Memorandum to the City of Markham Committee of Adjustment

December 08, 2020

File: A/018/20
Address: 7 Shorthill Drive, Markham
Applicant: Junhua He & Fang Chen
Agent: Rachel Y.H. Sun Architect (Rachel Sun)
Hearing Date: Wednesday December 16, 2020

1 PROPOSED BASEMENT FLOOR PLAN
 A1.1 SCALE: 3/16"=1'-0"

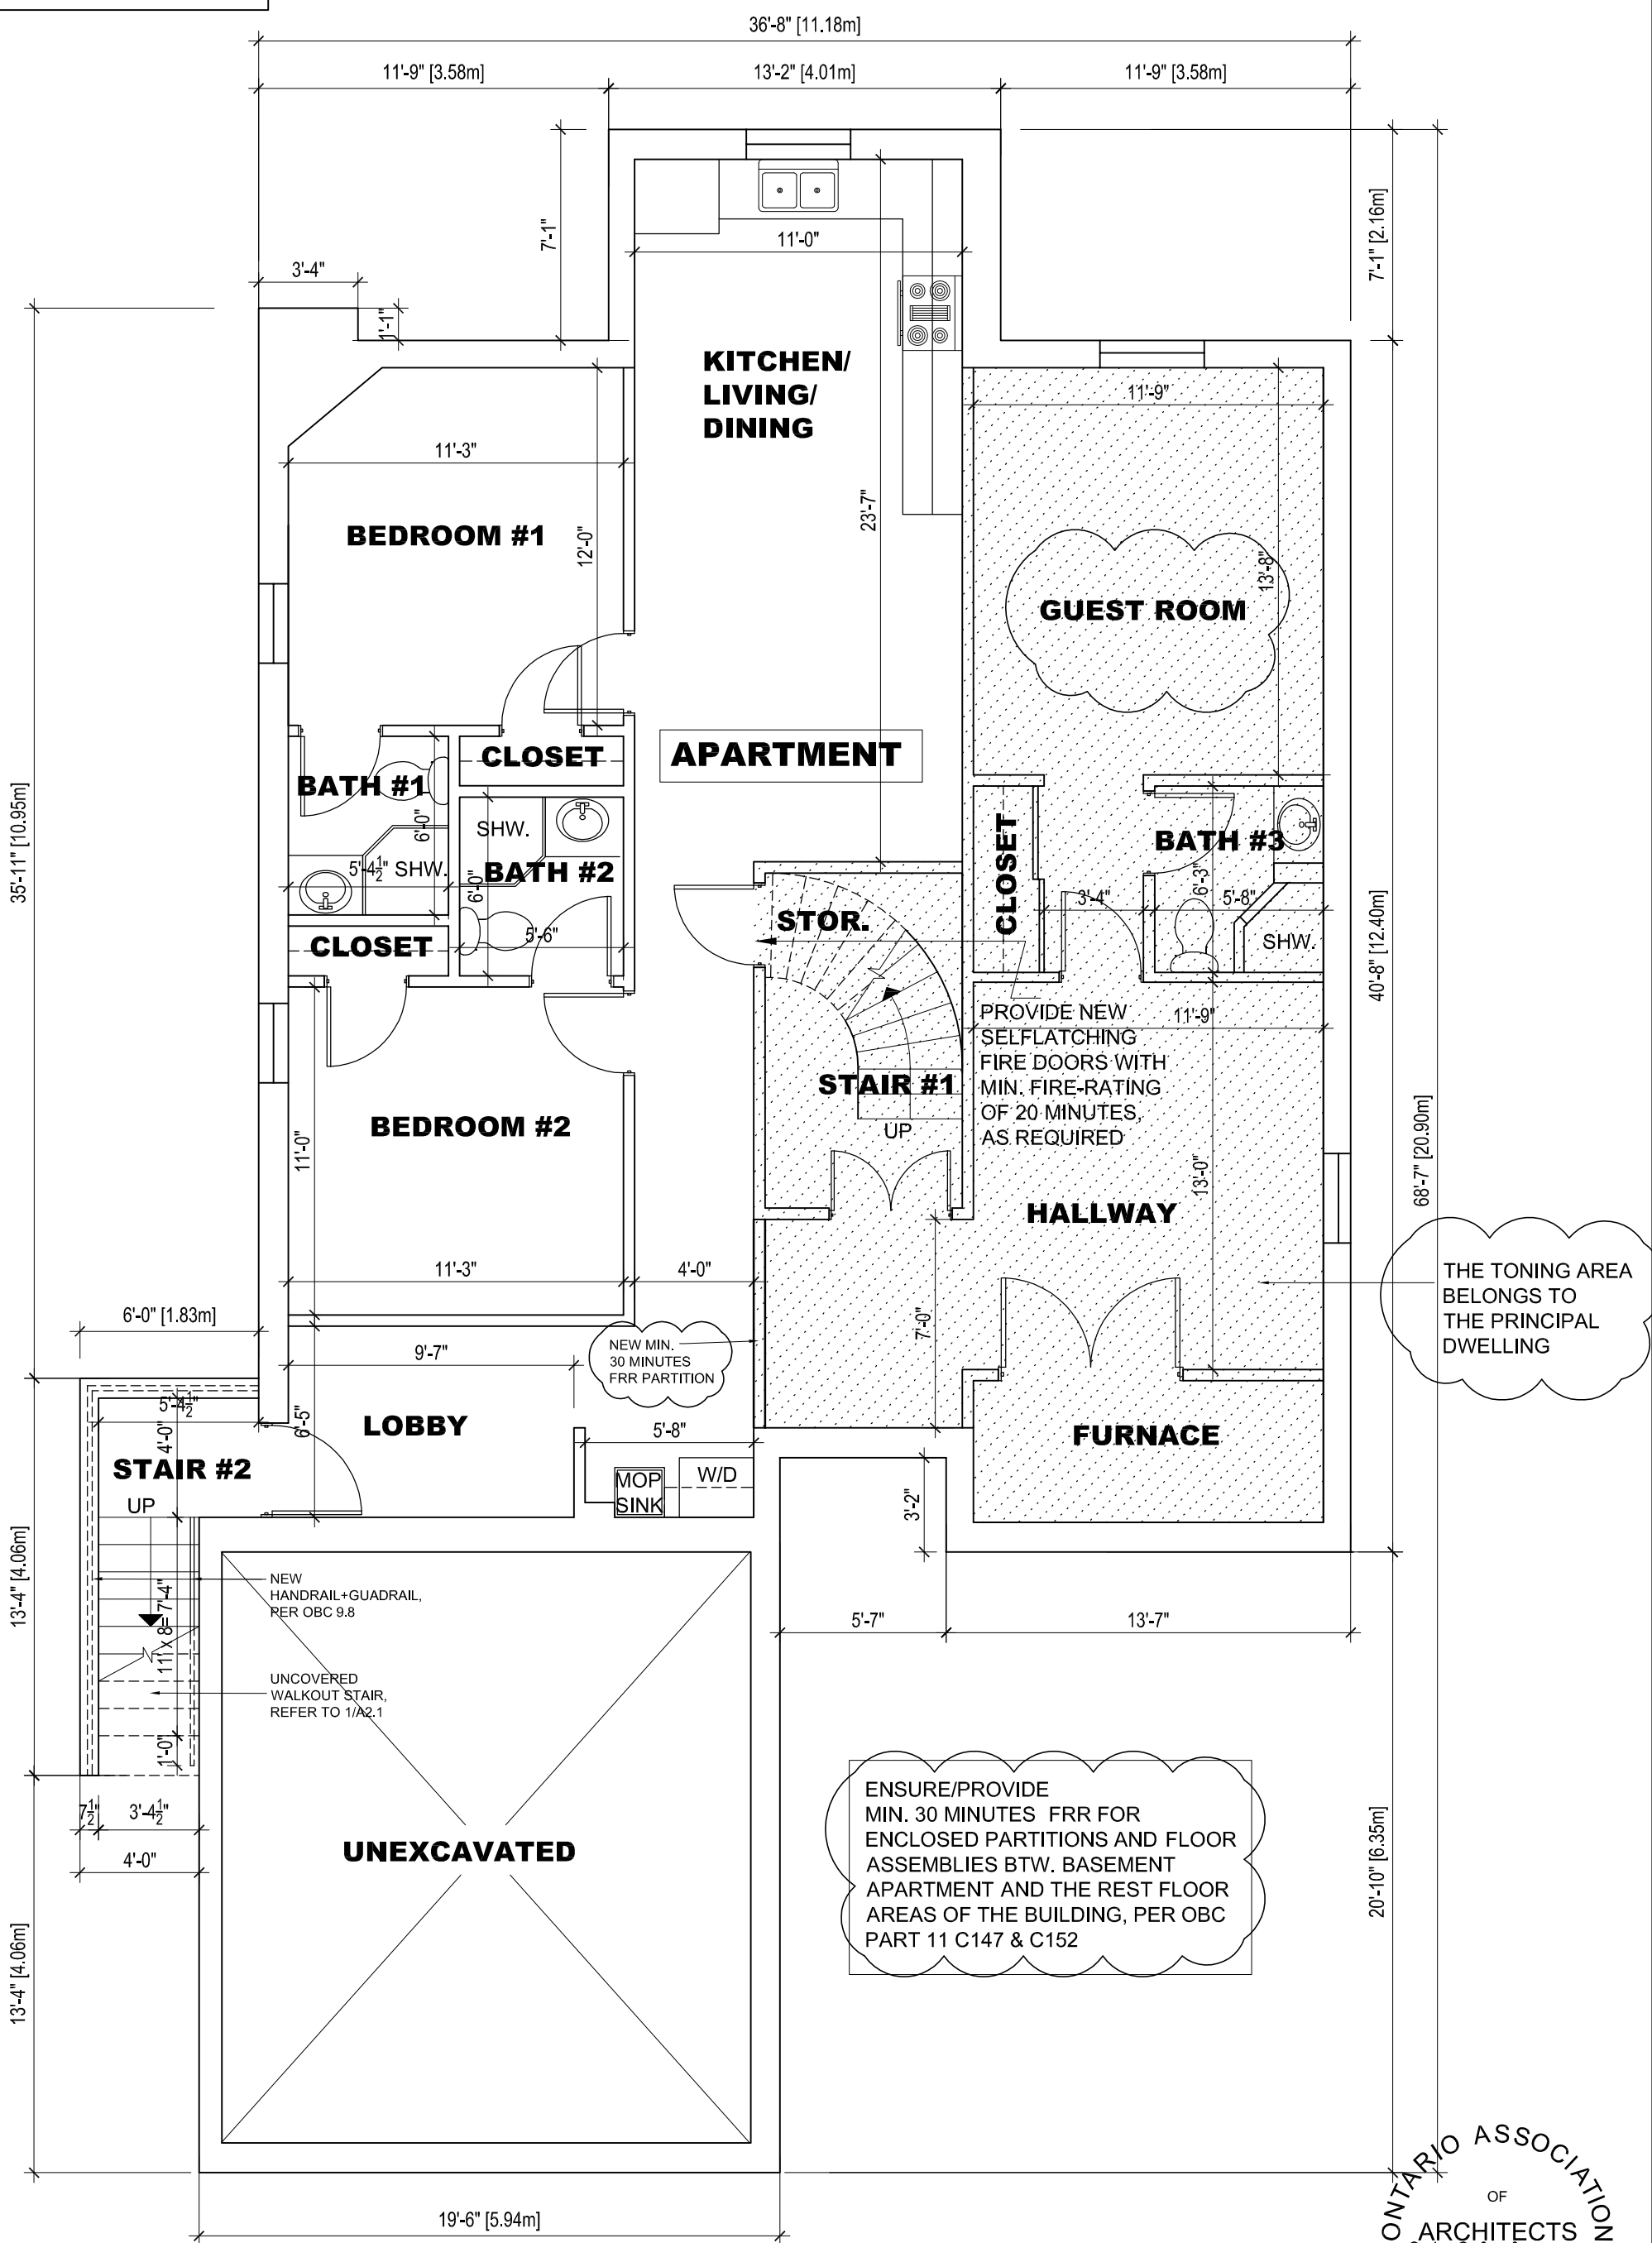
The Committee of Adjustment deferred the application on November 4, 2020 due to concerns expressed by the Committee relating to the number of people living in the basement and the basement floor plan layout. The Committee requested that the Agent come back to the Committee with a revised basement floor plan that demonstrates a separation between the basement apartment and the principle dwelling.

The Agent provided a revised basement floor plan (attached as Appendix “A”) addressing the Committee’s concerns, dated November 26, 2020. The revised basement floor plan demonstrates the following changes:

- A new min. 30 minute Fire Resistant Rating (FRR) partition wall will be installed, separating the basement apartment from the portion that belongs to the principle dwelling. The partition wall will be located between the basement apartment lobby and hallway belonging to the principle dwelling;

Staff note that proper fire separation is required between an accessory dwelling unit and the principle dwelling under the Ontario Building Code. If approved, any deficiencies

relating to building and fire code compliance will be addressed at the building permit application review stage.

- The guest room and hallway portions of the basement belonging to the principle dwelling are solely accessible through the main dwelling unit staircase (Stair #1);
- The basement apartment unit is solely accessible through the exterior stairs (Stair #2);
- There is no ability to physically move between the basement apartment and the portion of the basement belonging to the principle dwelling; and,
- The kitchen, originally located in the hallway portion of the basement belonging to the principle dwelling, has been removed from the plans.

Staff note that our comments and conditions dated October 5, 2020 (attached as Appendix "B") remain applicable. In addition, Staff recommend as an additional condition of approval, that the principle dwelling and accessory dwelling unit be solely accessed by separate entrances, and not through a common hallway or entrance (See Addendum contained in this memorandum).

5. That the principle dwelling and accessory dwelling unit be solely accessed by separate entrances, and not through a common hallway or entrance.

PROPOSED NORTH ELEVATION—WALKOUT STAIR

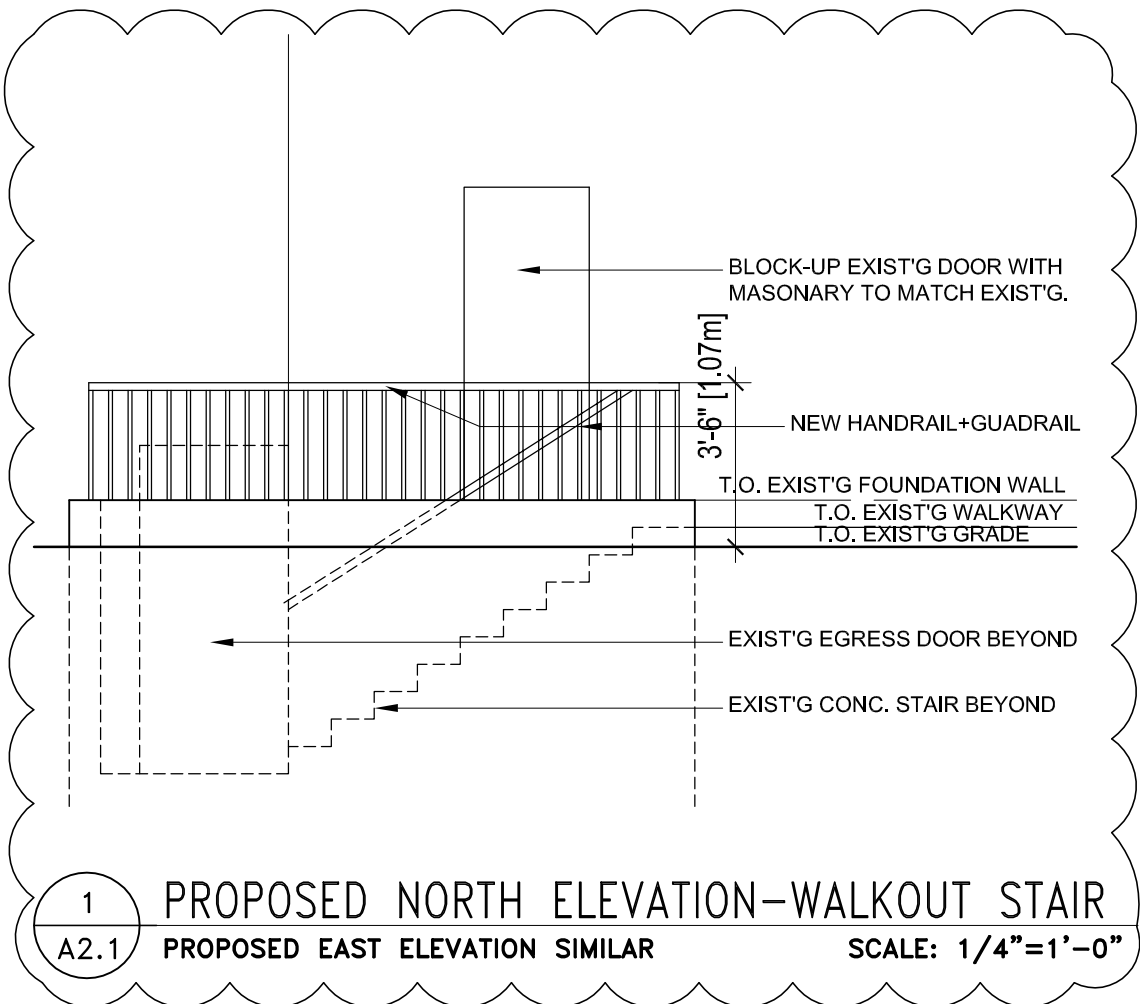
The applicant is requesting that the uncovered basement walkout stairs project a distance of 1.01 metres (3.31 feet) into the required interior side yard, whereas the by-law permits a maximum projection of 0.45 metres (1.47 feet).

The requested variance applies to the uncovered basement walkout stairs situated in the northerly side yard. The existing footprint of the building complies with all other By-law requirements. Engineering staff have reviewed the application and have no concern with the variance with respect to drainage. Staff are of the opinion that the proposed variance will not adversely impact neighbouring properties and have no objection to the requested variance.

It should be noted that the basement walkout stairs, as currently constructed, are enclosed. As per staff's request, the applicant has agreed to remove the enclosure, which has been included as a condition of approval (Appendix "A").

4. That the existing walkout stair enclosure be removed and that the walkout stairs in the northerly side yard remain unenclosed.
